Doc. No. BECO/ESR-1
SEPTEMBER 1984
REV. 1

Detailed Control Room Design Review

Executive Summary Report

Pilgrim Station

FIGURE 3-10.
PROPOSED TBCCW ARRANGEMENT

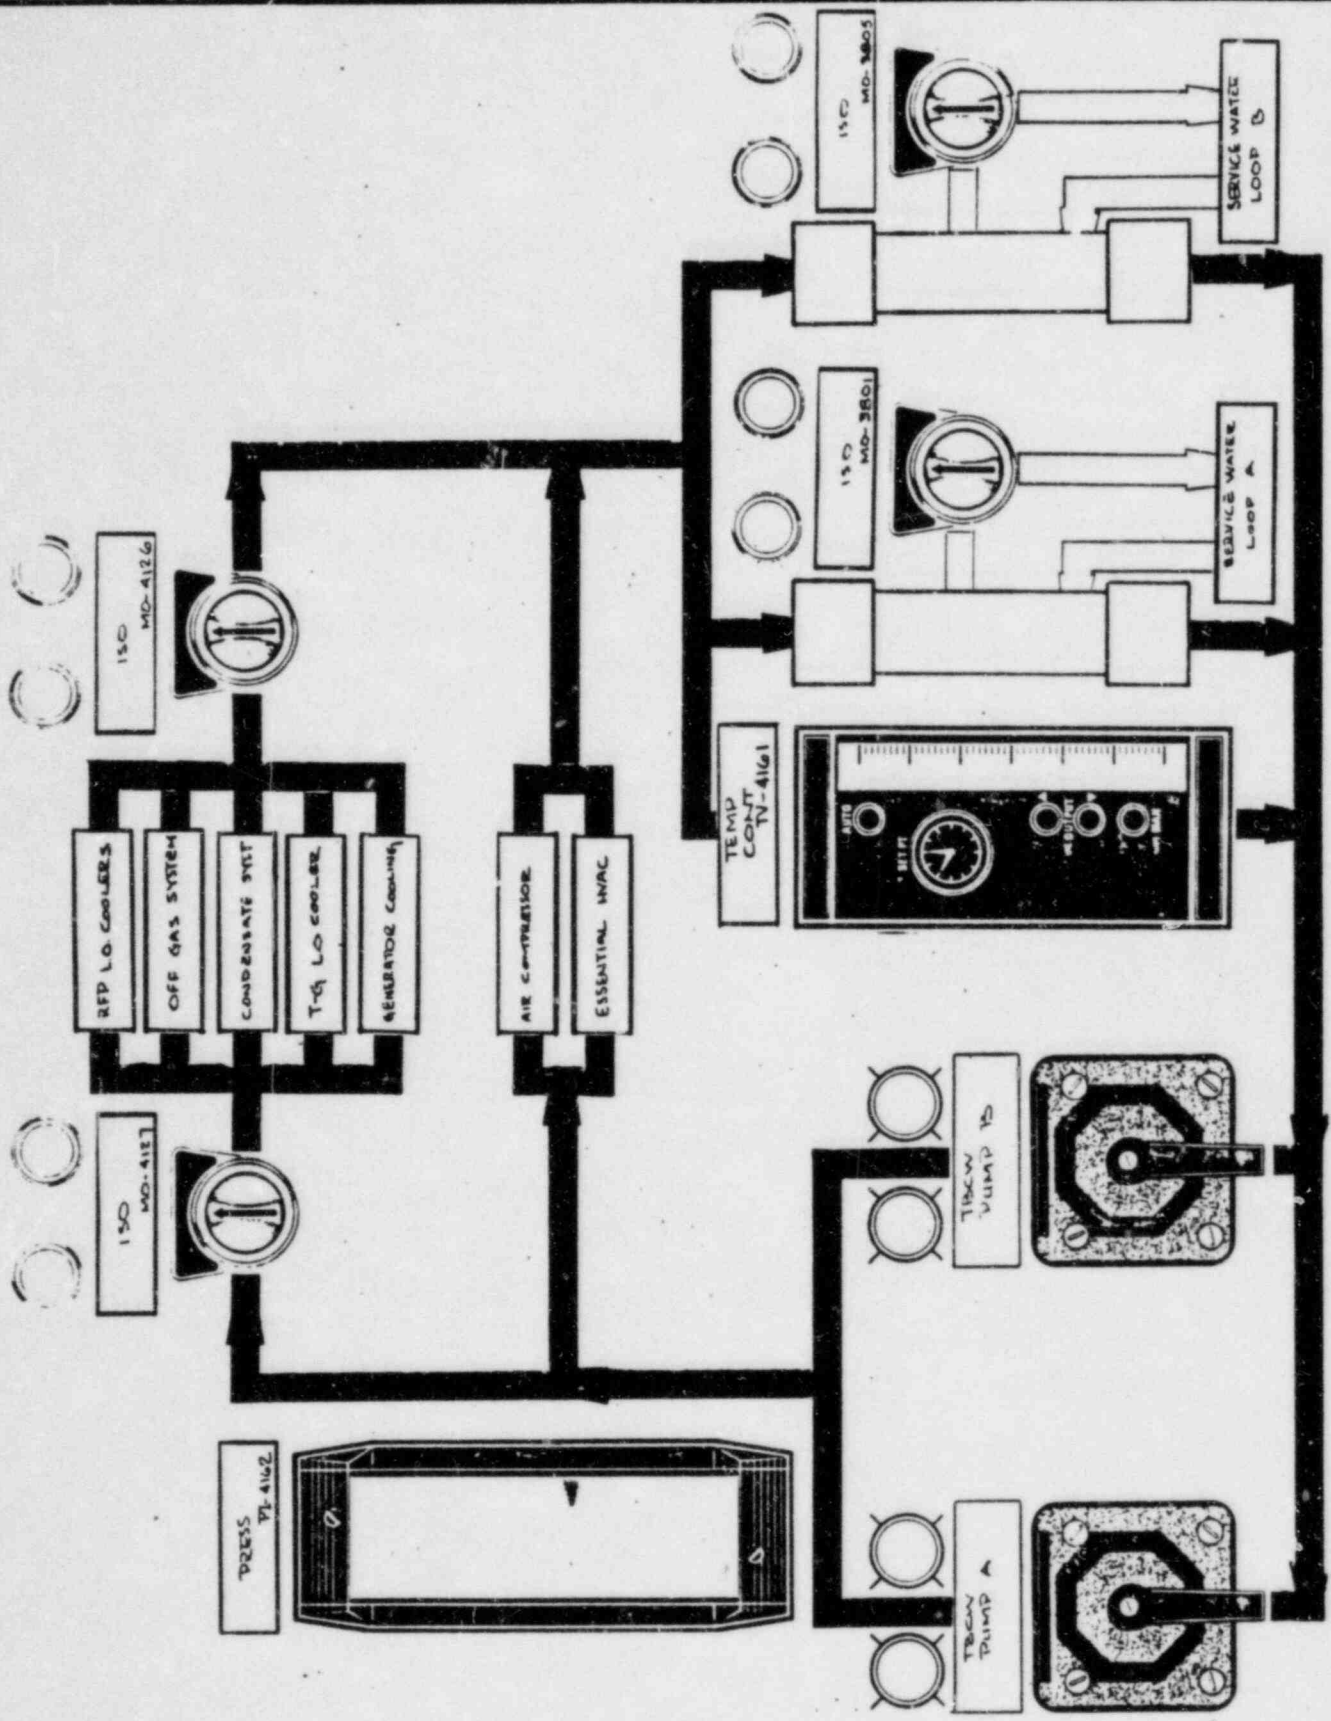
Figure 3-10 is the proposed TBCCW arrangement. It features a graphic presentation to show the interrelationship with the service water system and the

various systems coolers that it supports. Temperature control has been integrated into this layout, thus eliminating the disassociation of the controller with the remainder of the components of the system. Header pressure was also relocated into the arrangement to provide an integrated layout and provide indication feedback at the same location that the control action takes place. Since low header pressure and the TBCCW head tank level are annunciated, this is a desirable feature. Figure 3-12 shows the present location of these components.

FIGURE 3-11.
PROPOSED RBCCW AND SERVICE
WATER ARRANGEMENT

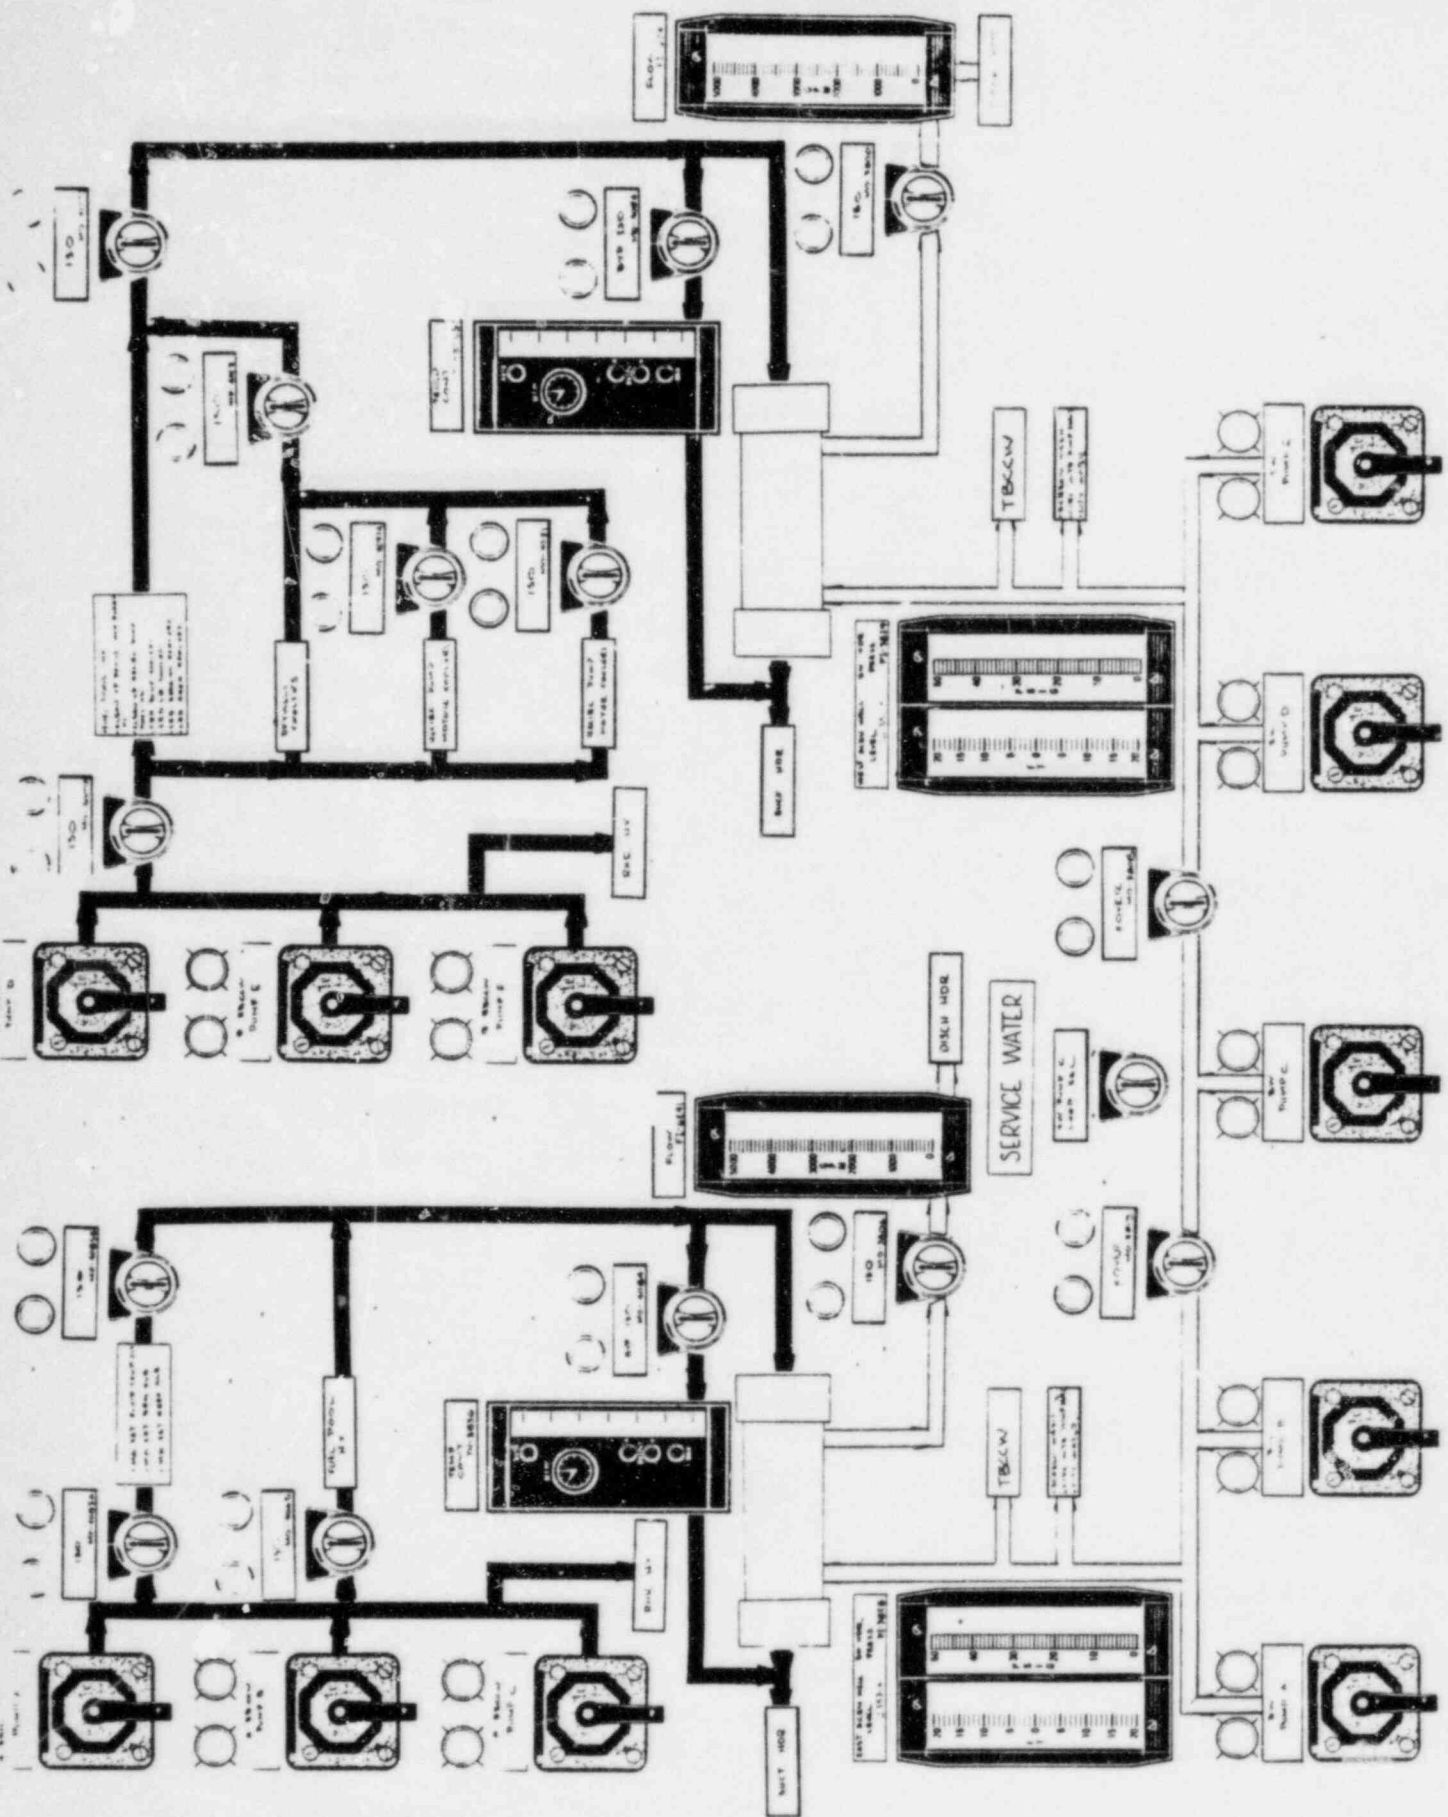
Figure 3-11 is the proposed arrangement for the RBCCW and Service Water Systems. It features a graphic representation to show the interrelationships that the service water system has with RBCCW Loops A and Loop B. It also shows the tie-in with the TBCCW, Screen Wash System, Circulating Water Pumps, and city water. It is intuitive from the arrangement that alternate lineups can be made and what they are.

Temperature control and several meters have also been incorporated into the arrangement to enhance the association of system components in one location. Screen well level and service water header pressure indication have been put adjacent to each other in a common bezel because of the interrelationship of the sea level and the pump discharge pressure. Both parameters have low alarms. Figure 3-12 shows their current location on the panel.

FIGURE 3-12.
SERVICE WATER AND TBCCW
INDICATION AND CONTROL

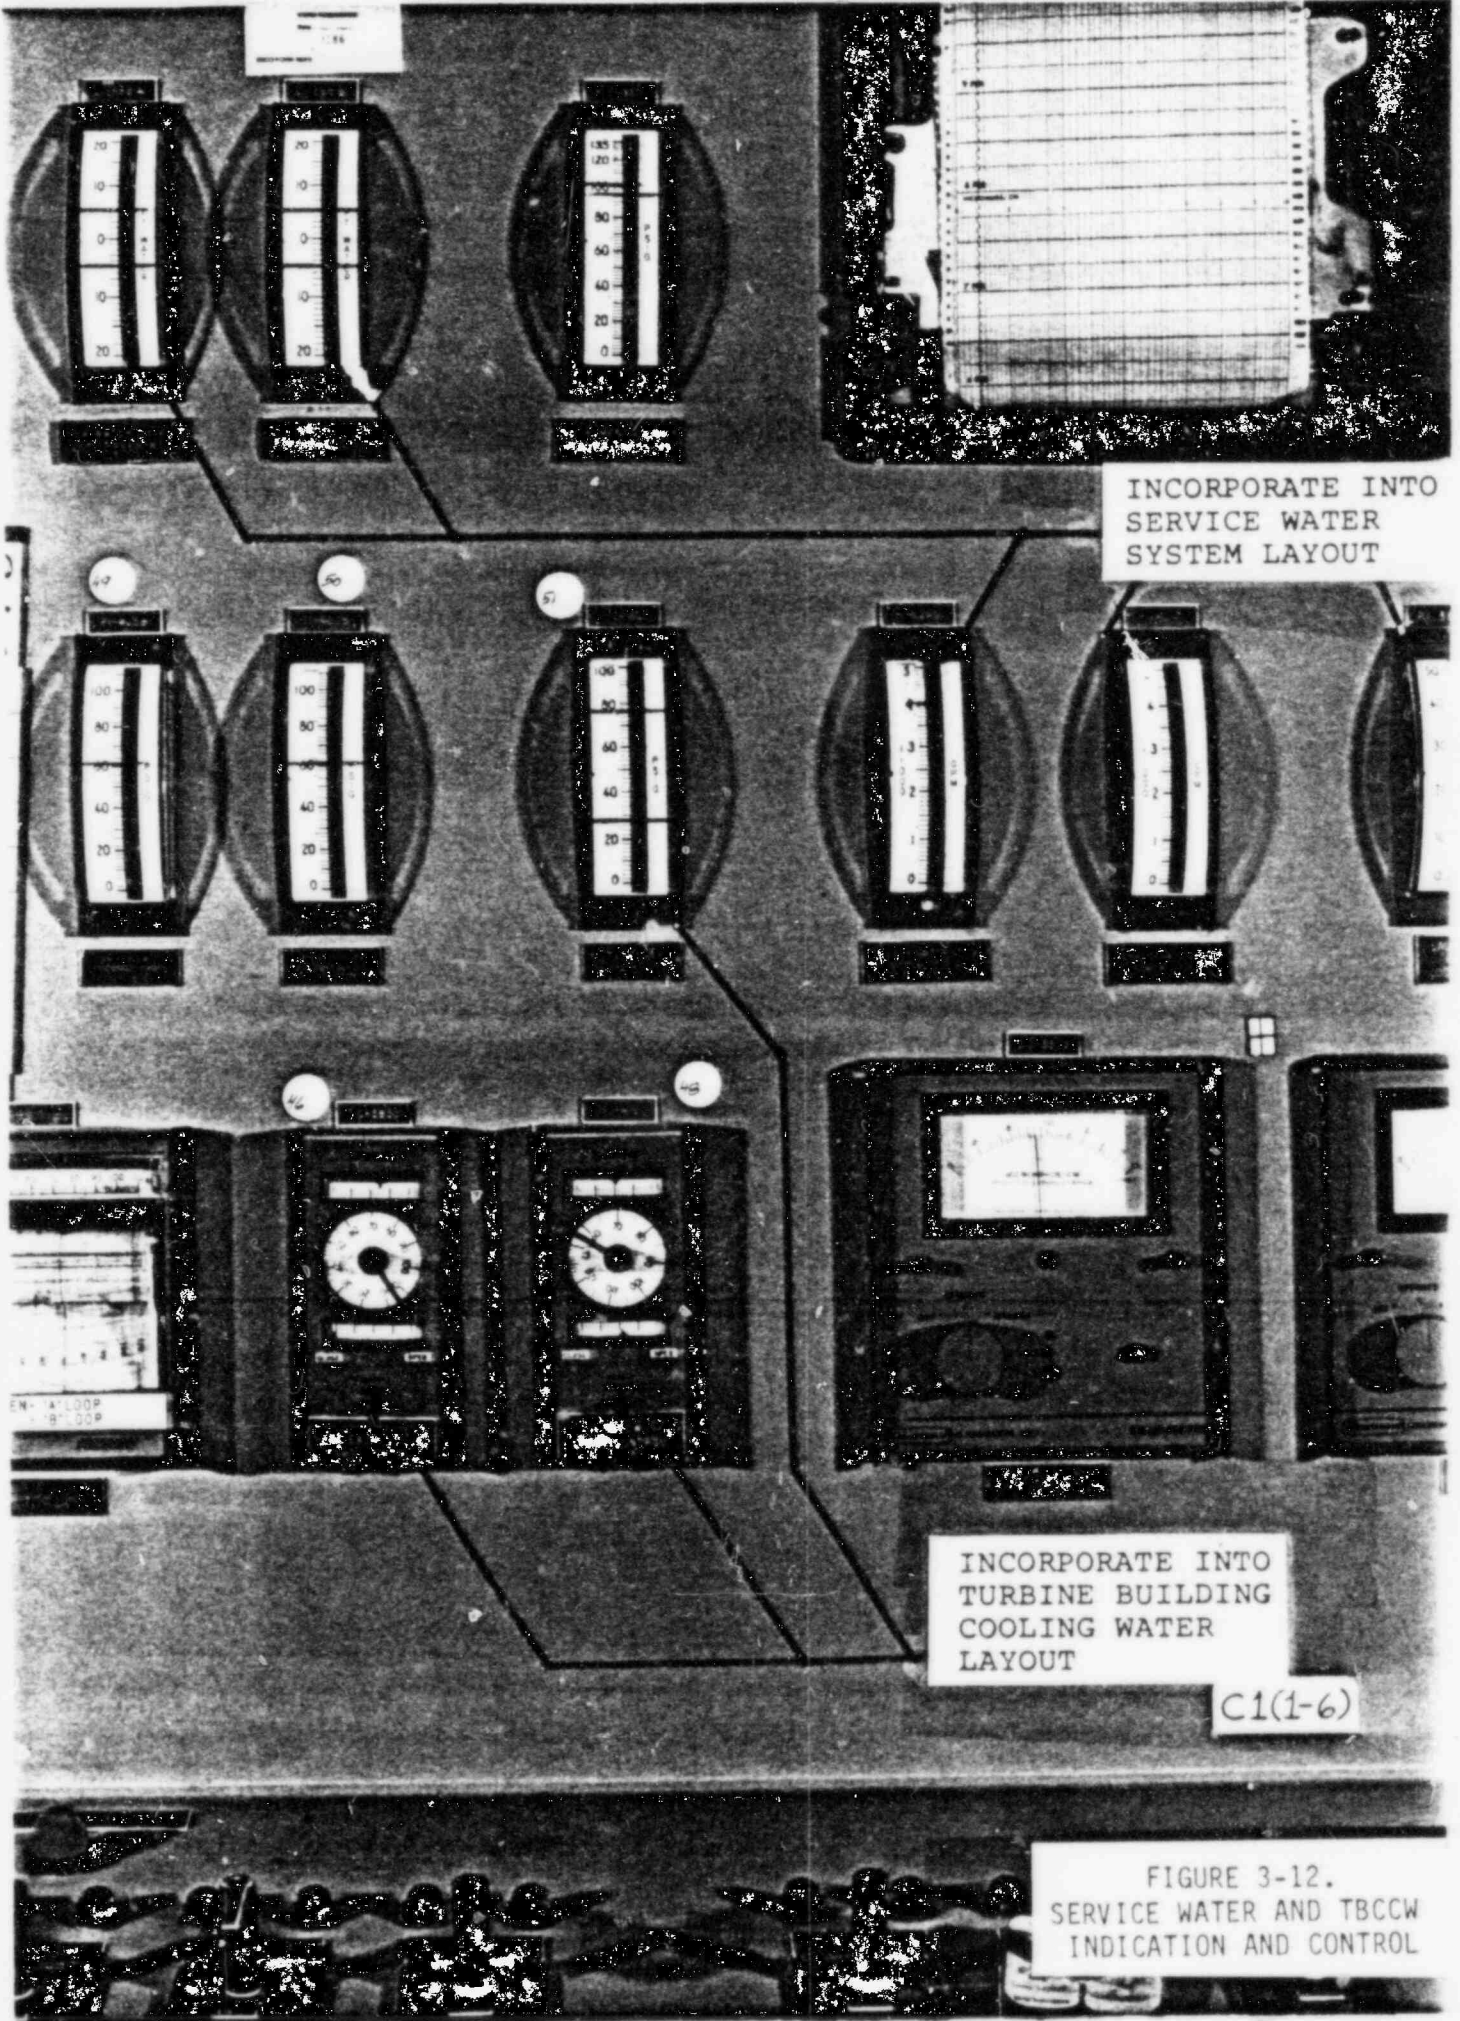
INCORPORATE INTO
SERVICE WATER
SYSTEM LAYOUT

INCORPORATE INTO
TURBINE BUILDING
COOLING WATER
LAYOUT

FIGURE 3-22. TURBINE OIL SYSTEMS

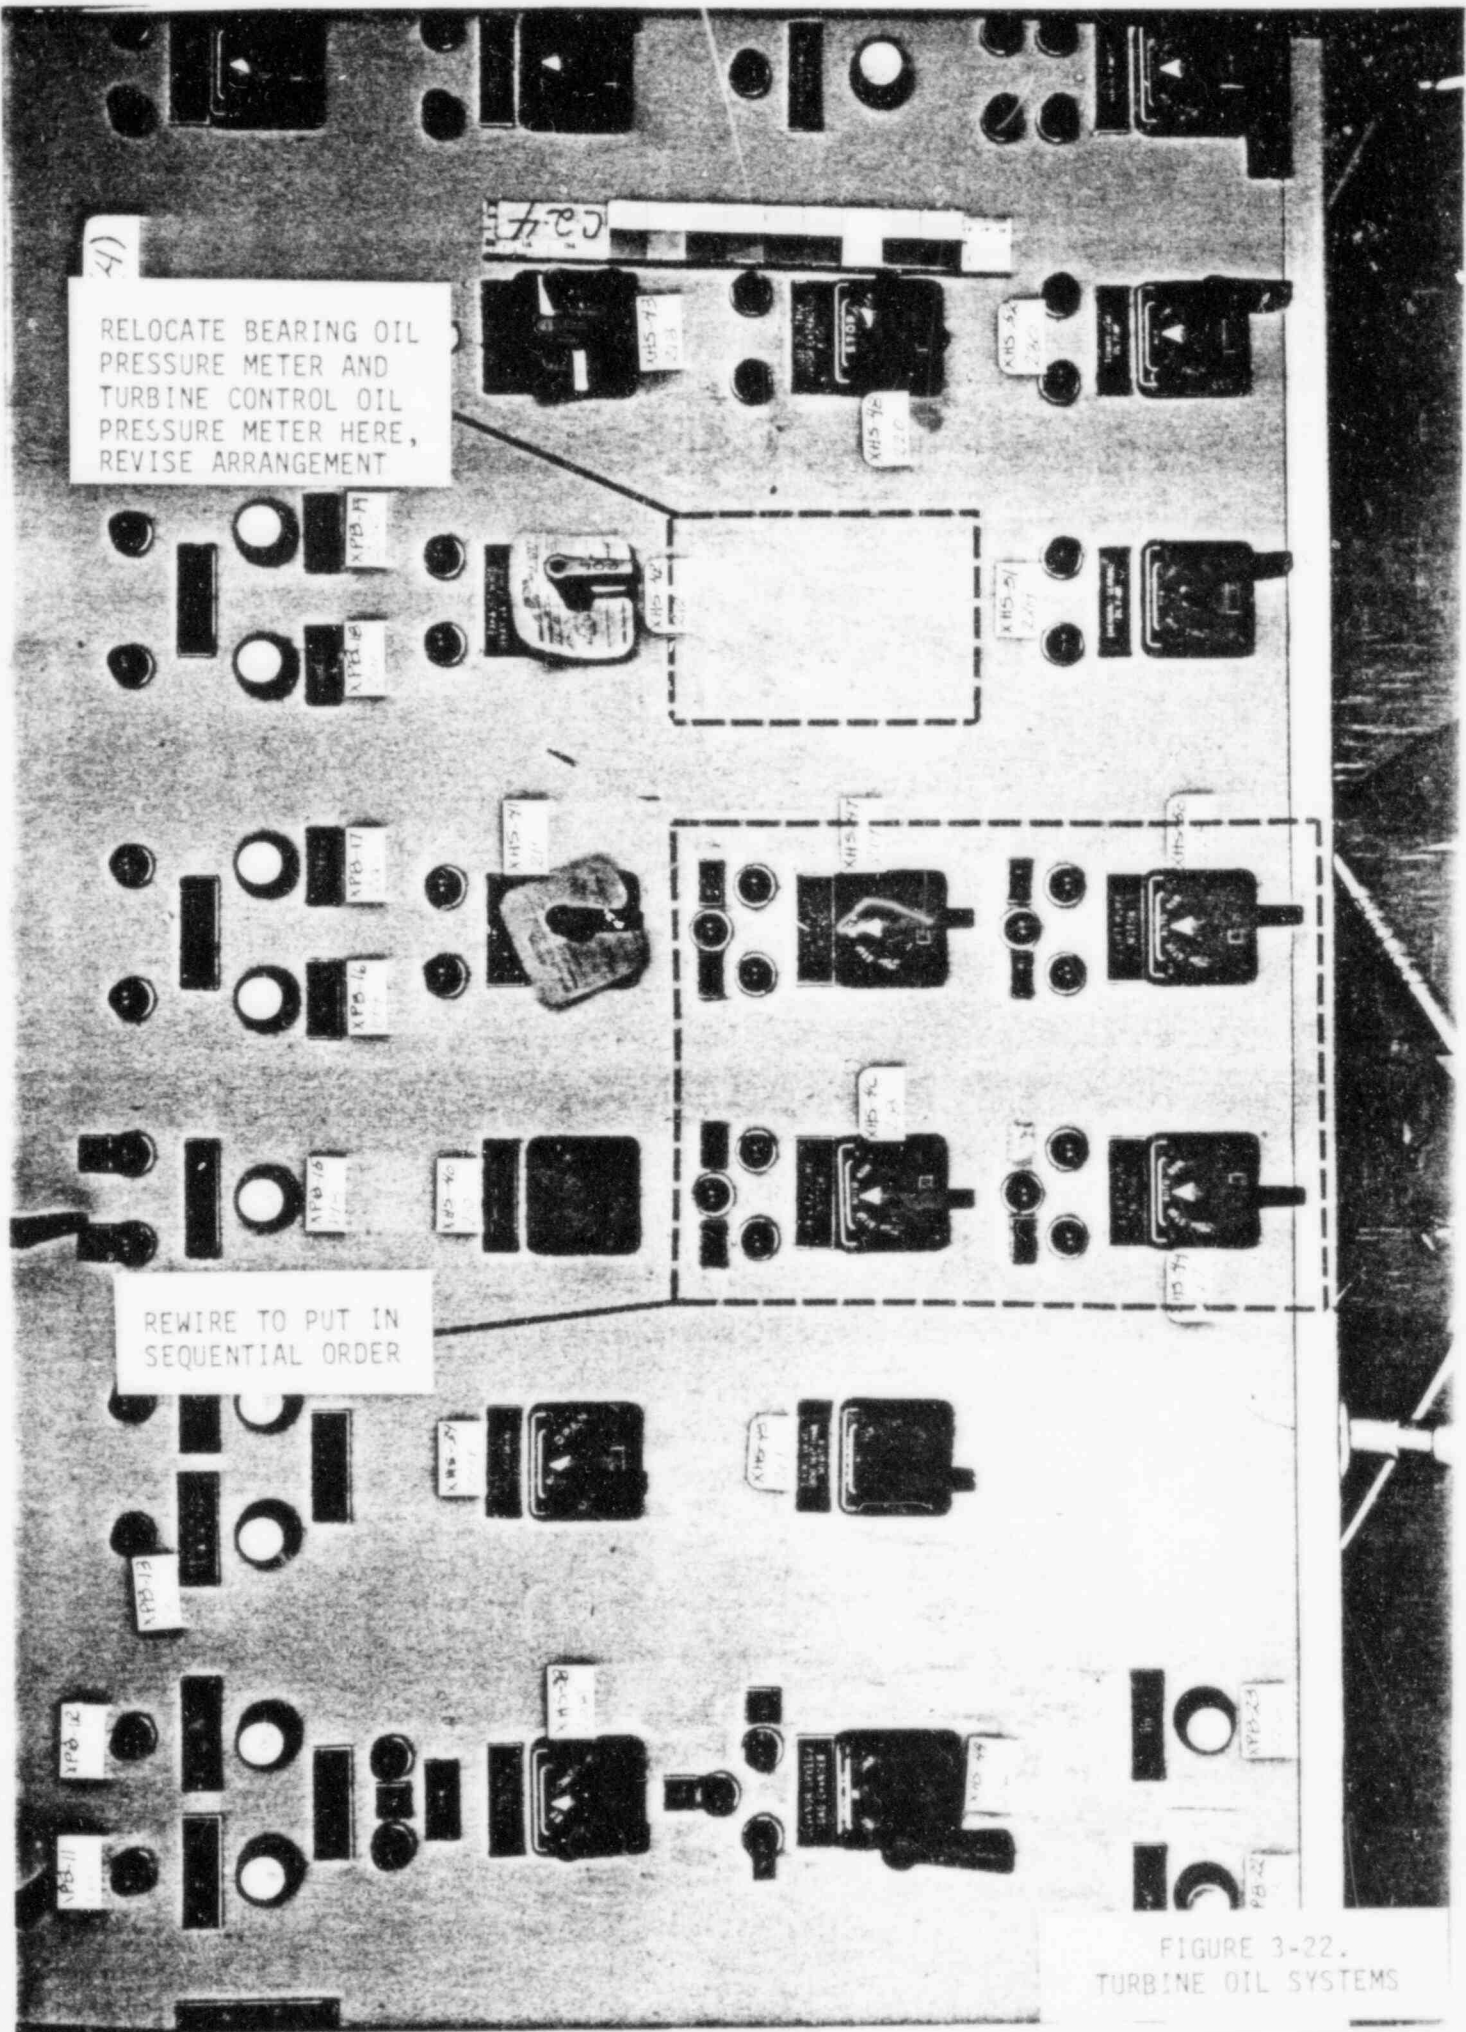
Figure 3-22 shows the lube oil pumps control associated with HED 9B109.5. Incorporation of the bearing oil pressure and control oil pressure meters will require rearrangement of the equipment on the panel. This will cause a domino effect, requiring several other subsystems to be revised.

4)
RELOCATE BEARING OIL PRESSURE METER AND TURBINE CONTROL OIL PRESSURE METER HERE, REVISE ARRANGEMENT
